ADDENDUM NO. SEVEN

October 8, 2024

Lamont Park Beautification Project

1650.7012.22

JOB	W1
DP	
PM	
SHEET 15 OF 25

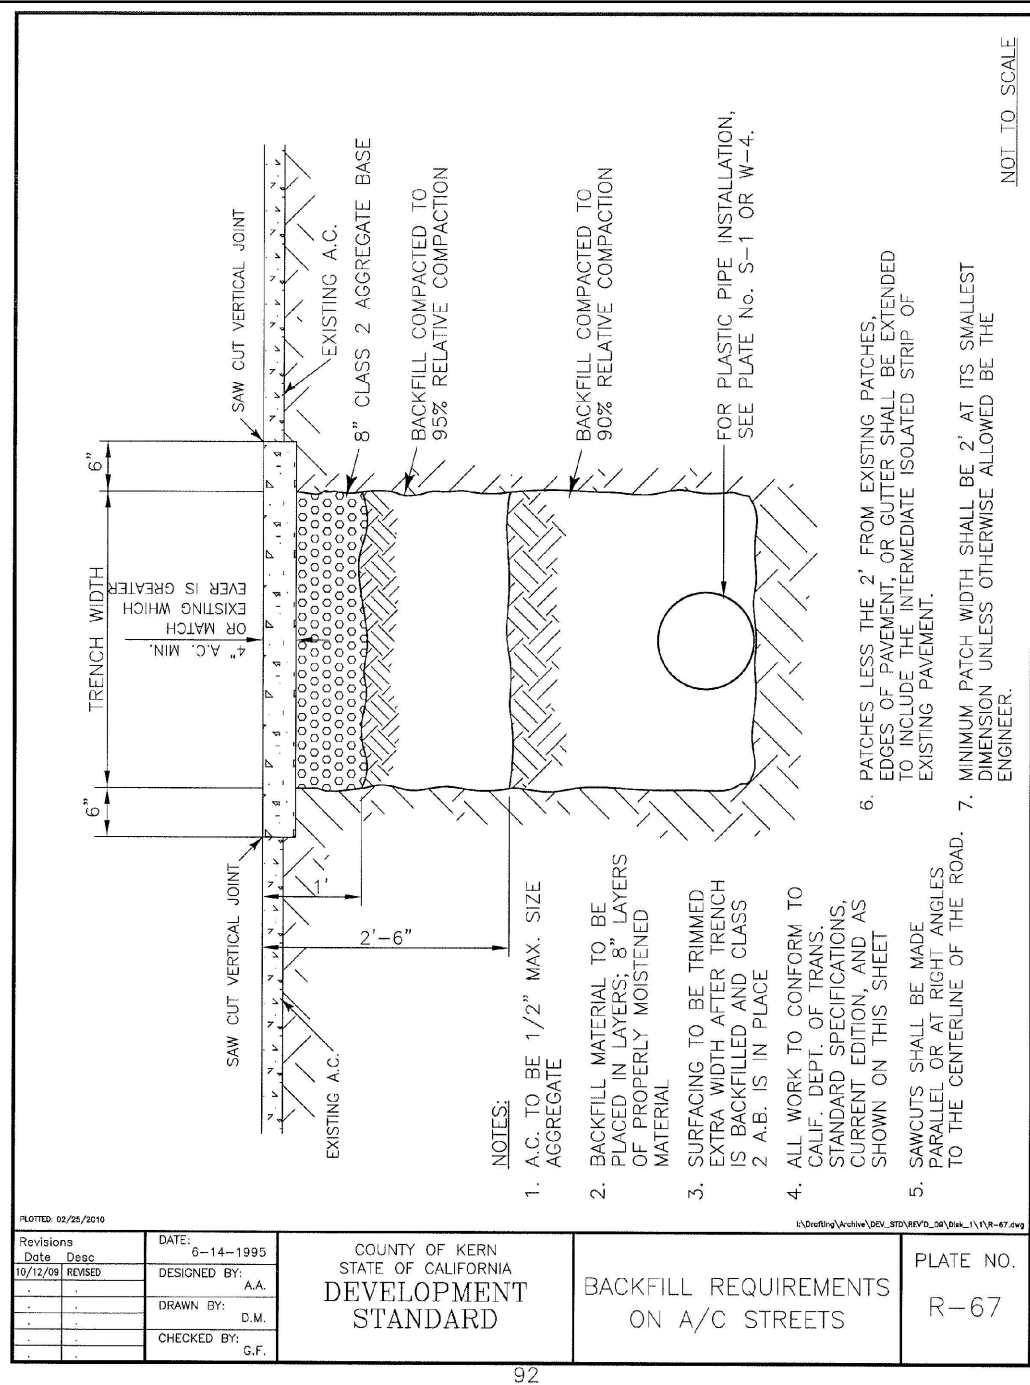
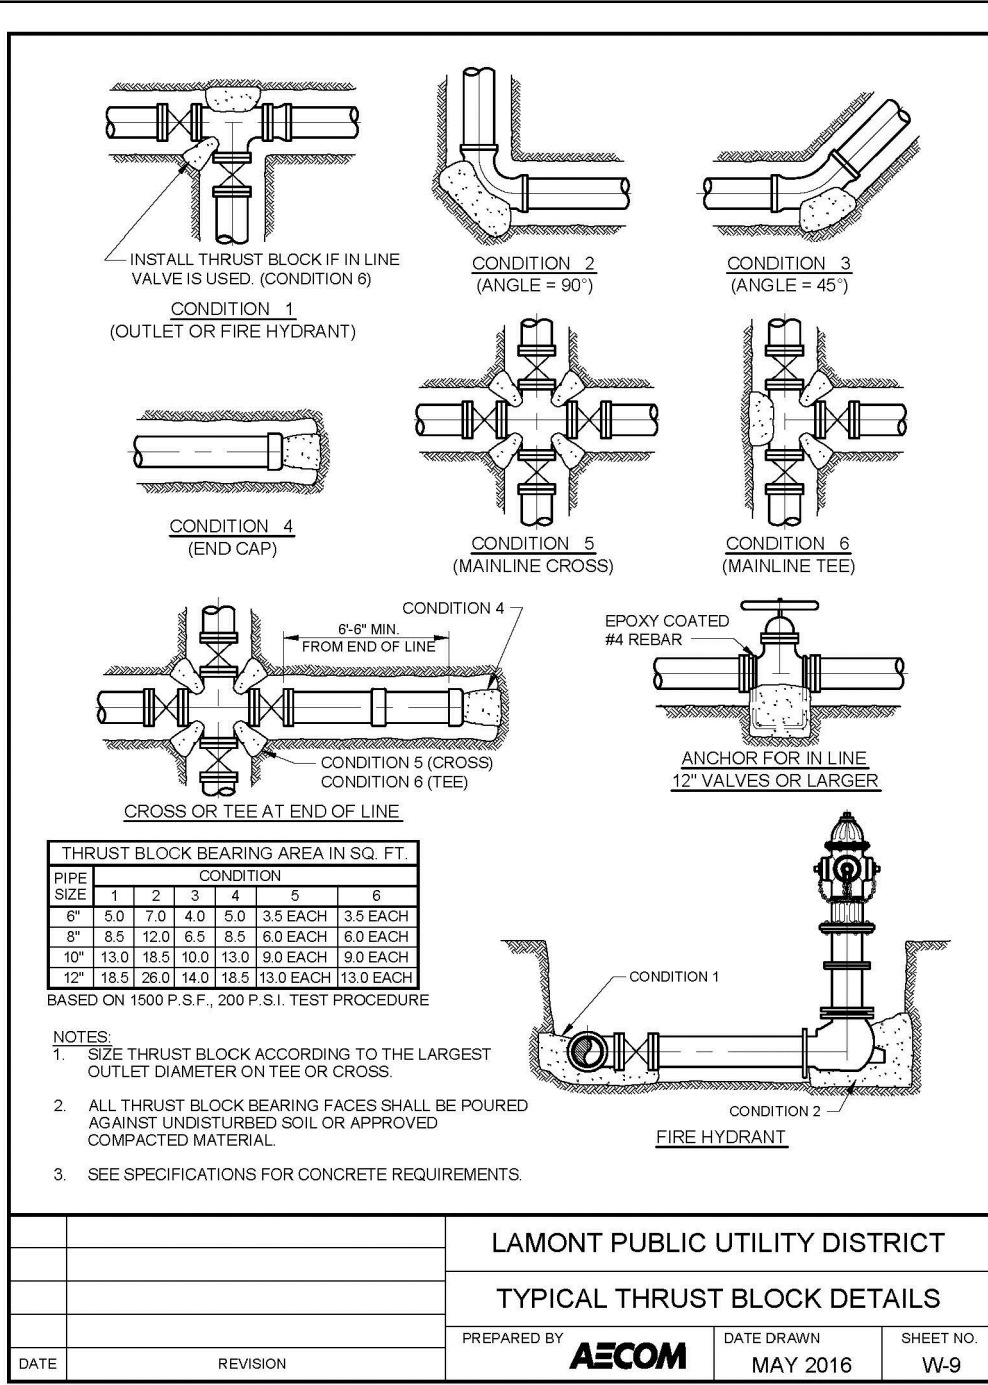
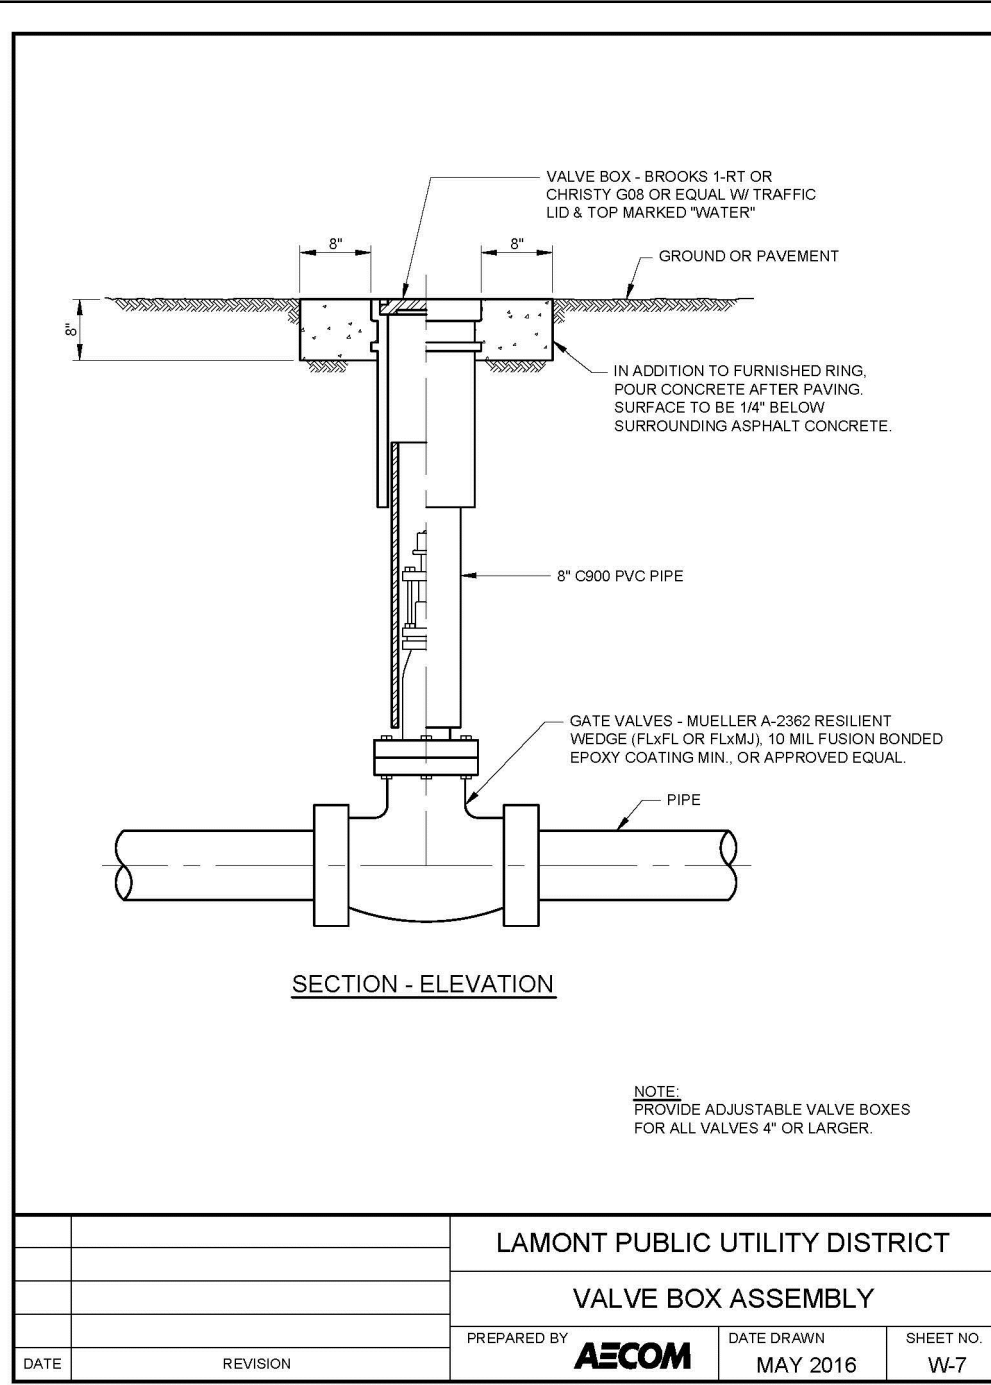
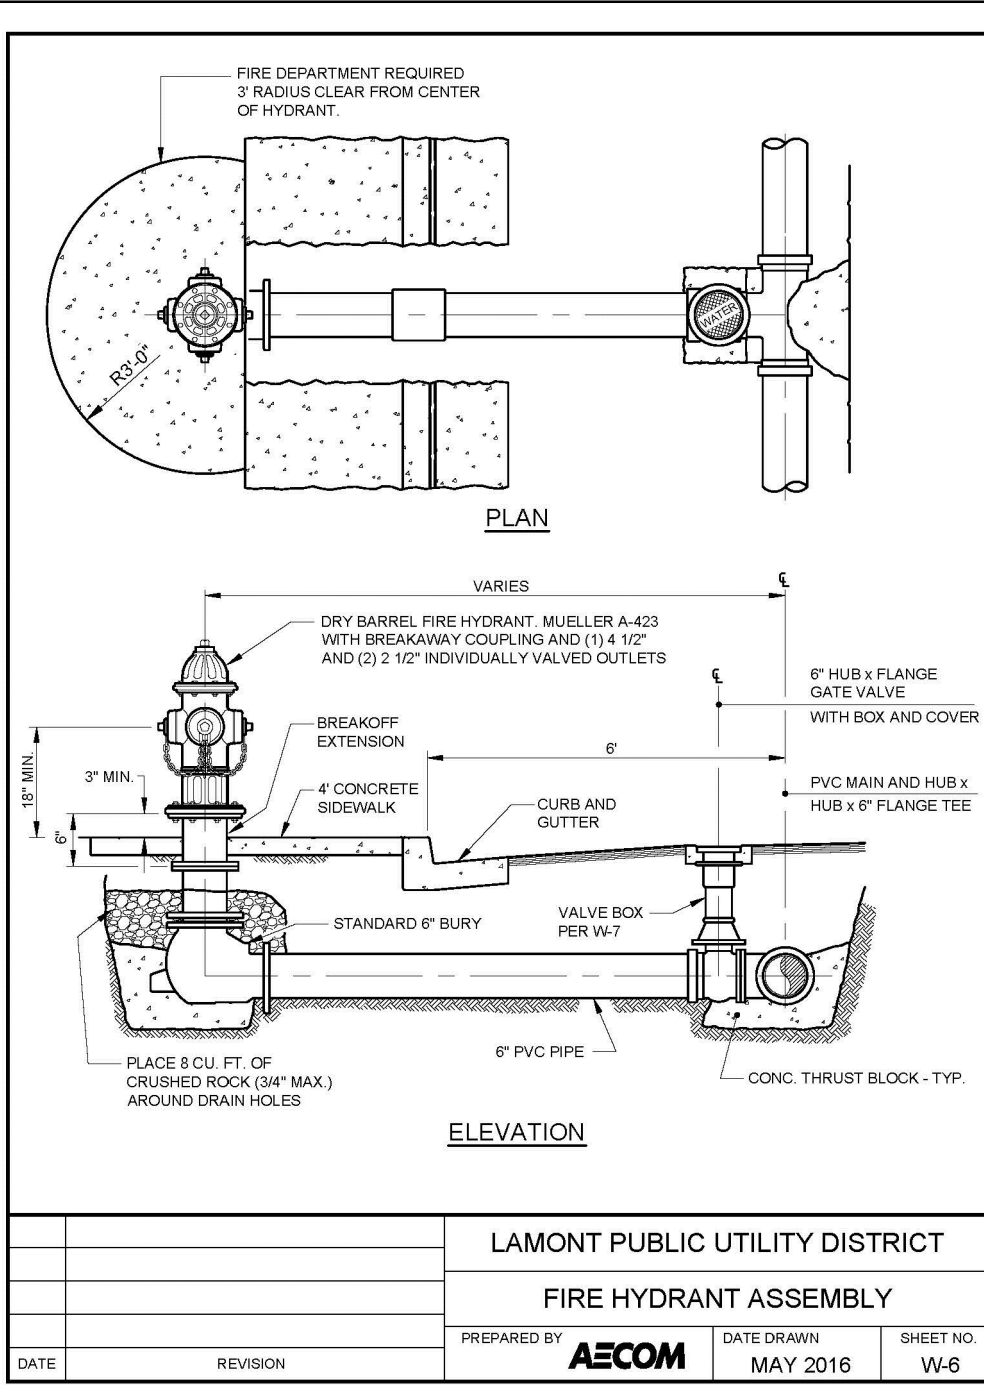
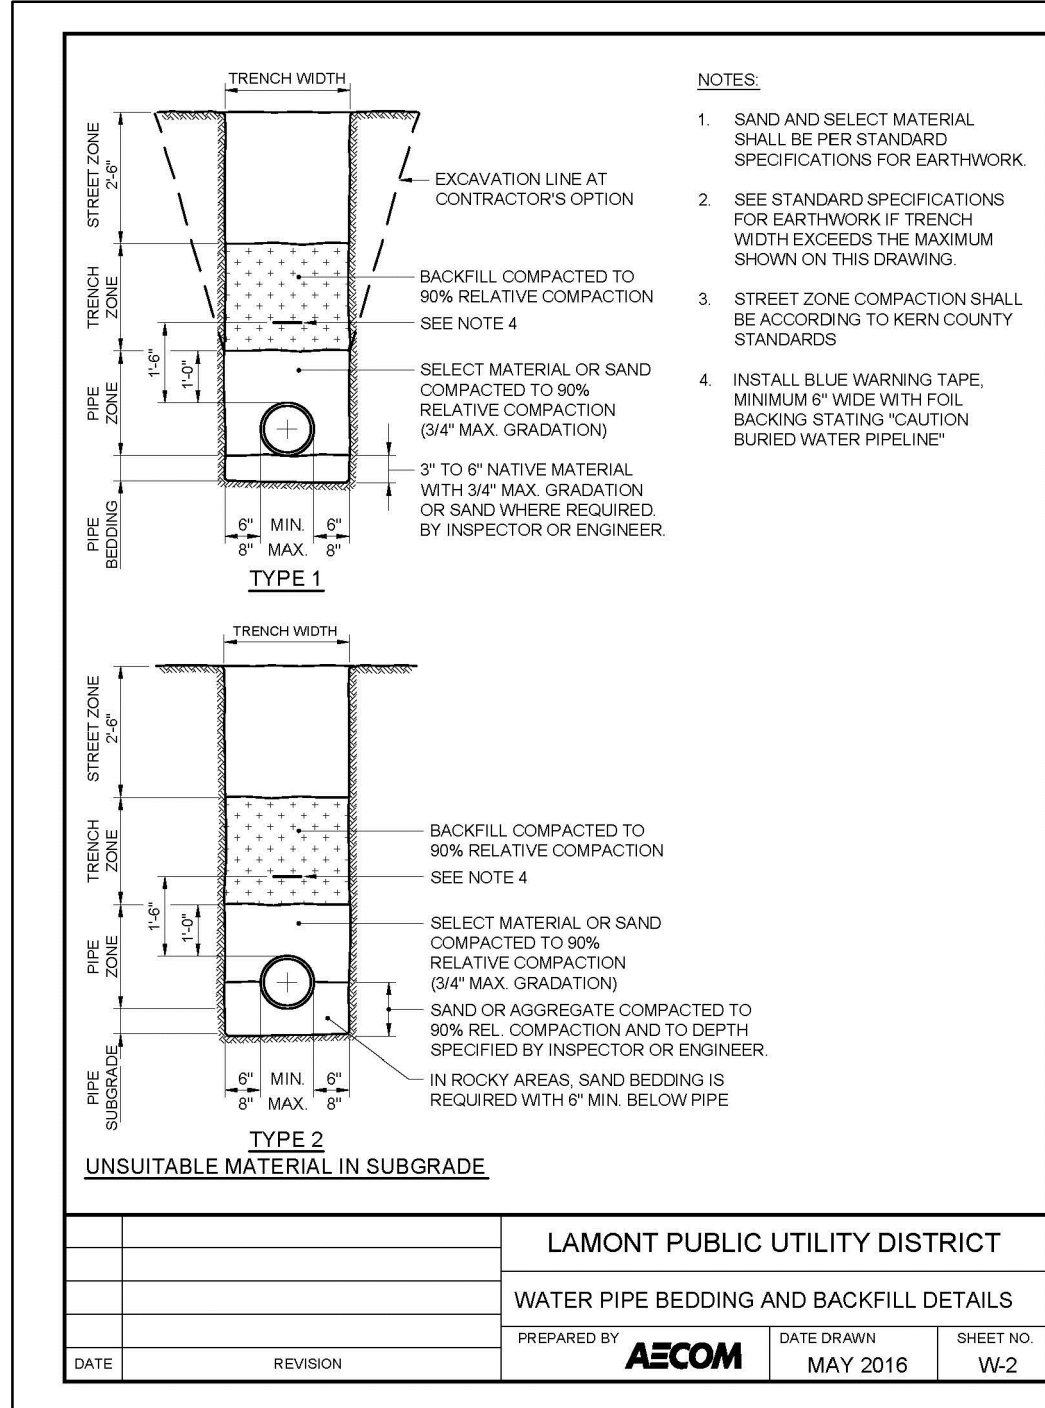
- Item No. 11:** Refer to attached sheet W1 and W2 and add to the Construction Documents all scope of work identified.
- Item No. 12:** Add to the contract sum Allowance no. 1 in the amount of \$5,000 (five-thousand dollars) for Hazardous Material removal from the project site. Refer to Specification Section 01 2000, Item d. Allowance Items for more information.
